ADDENDUM #1

Reference: Parleys Maintenance Station #234 Improvements
Utah Department of Transportation - Utah
DFCM Project No. 08211900

DFCM Project No.: 08211900
Archiplex Group Project No.: 0728.02

ADDENDUM NO. 1 to the Contract Documents for the Construction of UDOT Maintenance Station #2434, Parleys Canyon, Utah.

C302

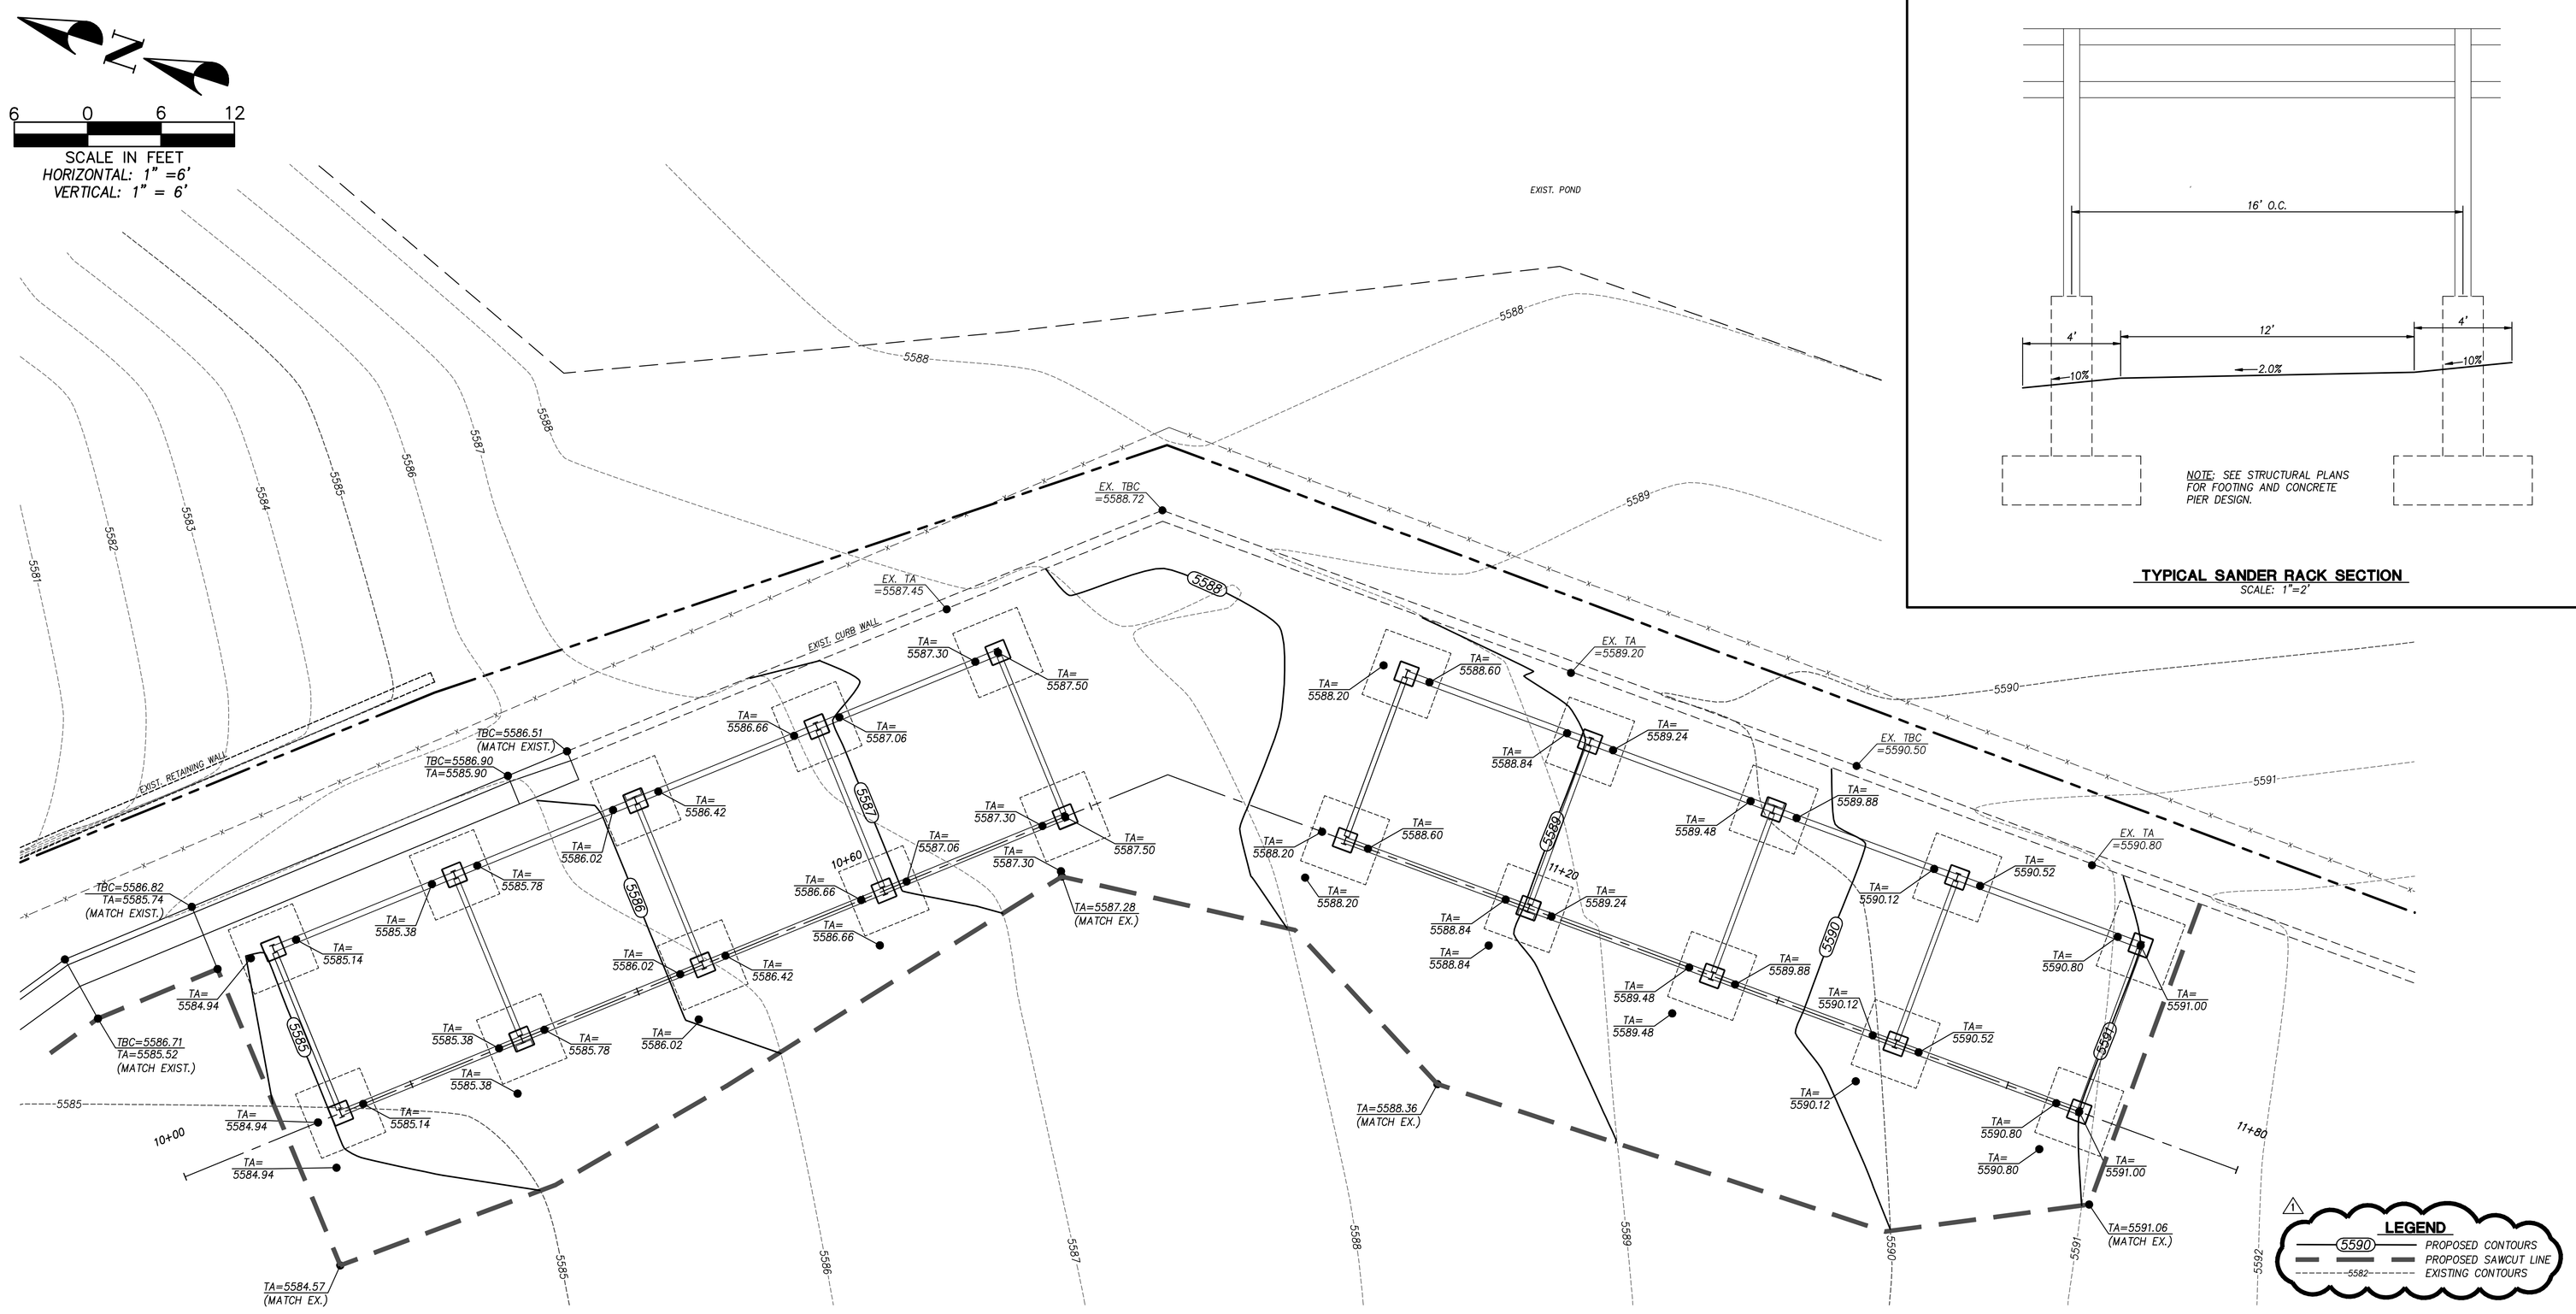
Sheet C302:

a. Added proposed contour lines and legend.

SECTION A-A
SCALE: 1"=1'

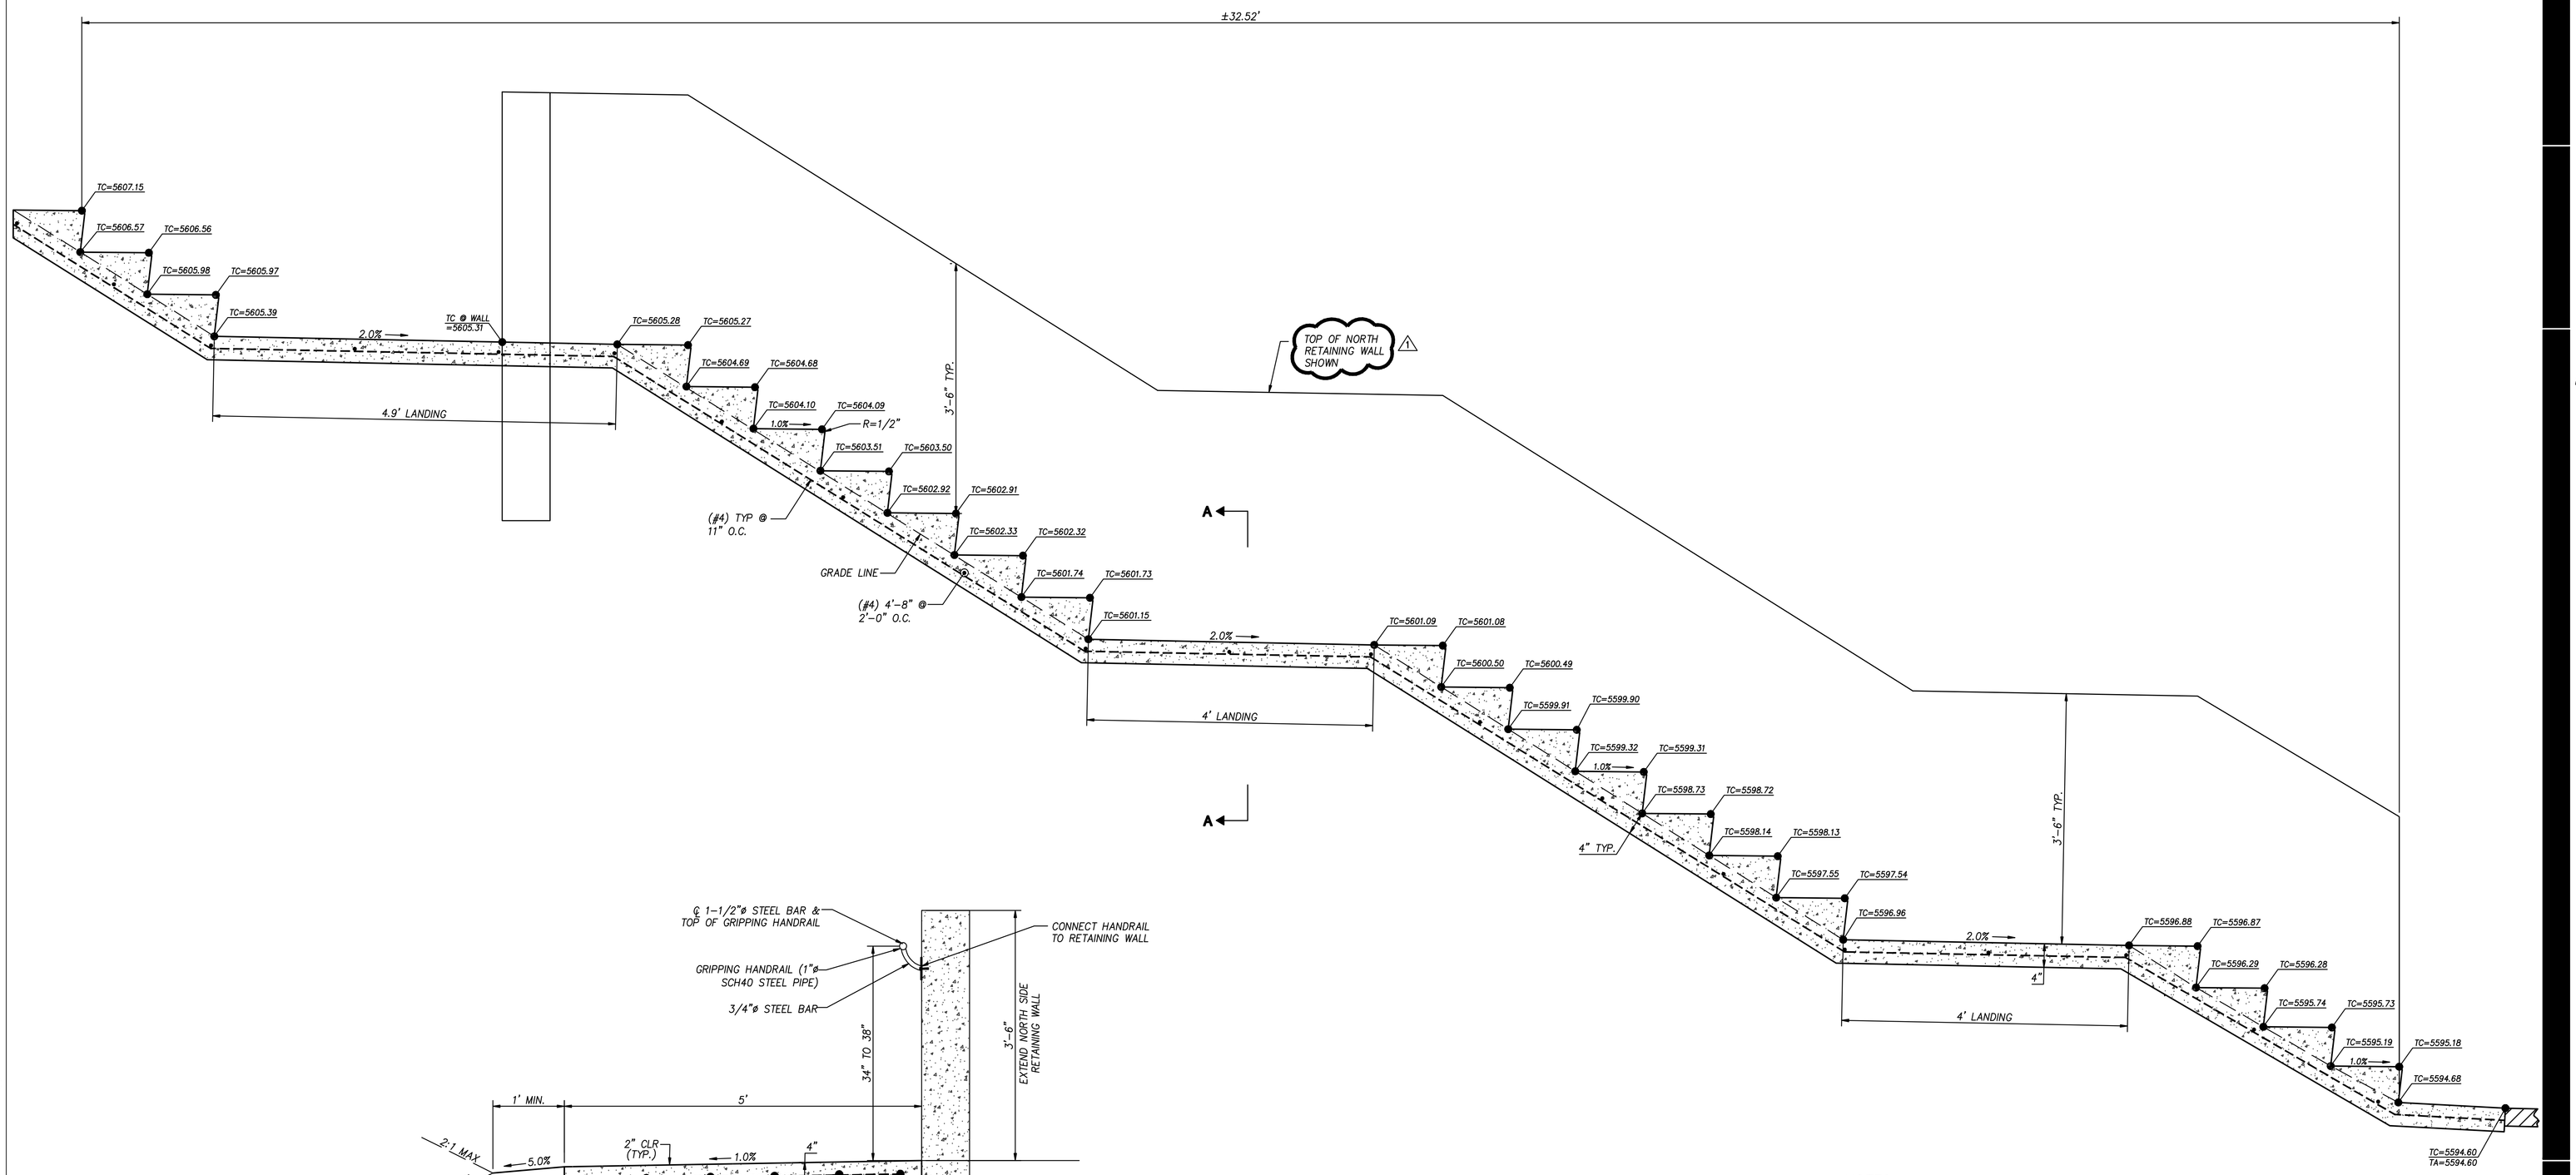
Sheet C500:

a. Added concrete paving design for dumpster & card reader pad.
b. Reversed section A-A callout.
c. Revised Section A-A.
d. Added note to clarify location of retaining wall.

SECTION VIEW

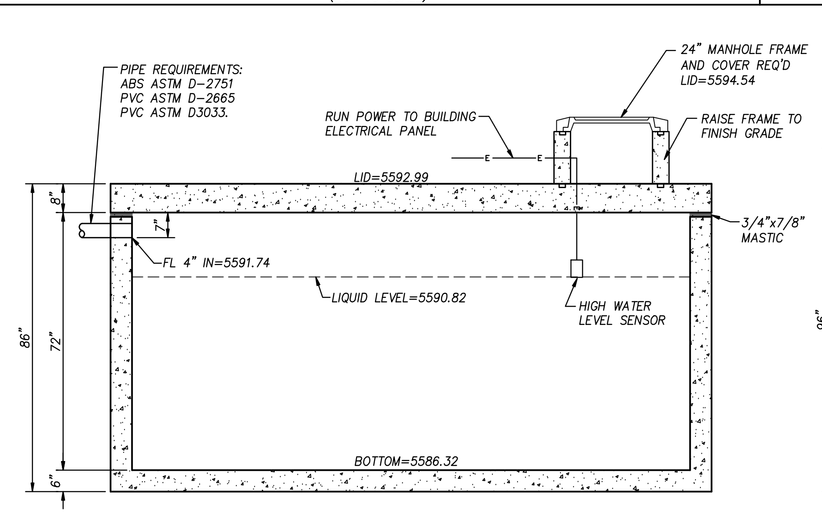
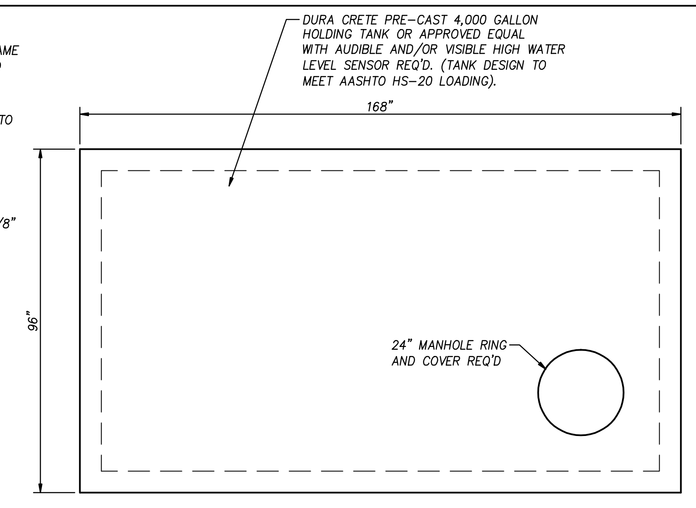
Sheet C501:

a. Added Holding Tank Detail.
